# Access Compliance Report

## Public Rights-of-Way

### (Curb Ramps)

| Intersection ID: 2421 | Main Street: CEDARDALE RIDGE CT | Cross Street: HIDDEN MEADOW LN | Location:              | W                  |

| ADA ID: A17528A07922  | Ramp Type: PerpDiag             | Initial Pass/Fail: Fail        | Overall Compliance: No | Severity Score: 25 |

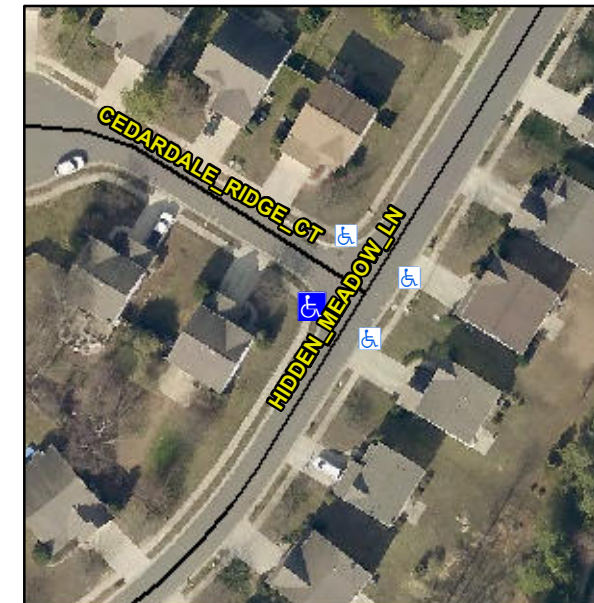
**Not Found, R304.5.3**

| Compliance | Description           | Data  | Compliance | Description                 | Data  |
|------------|-----------------------|-------|------------|-----------------------------|-------|
| Yes        | Ramp Width (in)       | 48.0  | No         | Ramp XSlope (%)             | 9.1   |

**Remove & Replace Curb Ramp With Two New Directional Ramps or Equivalent.**
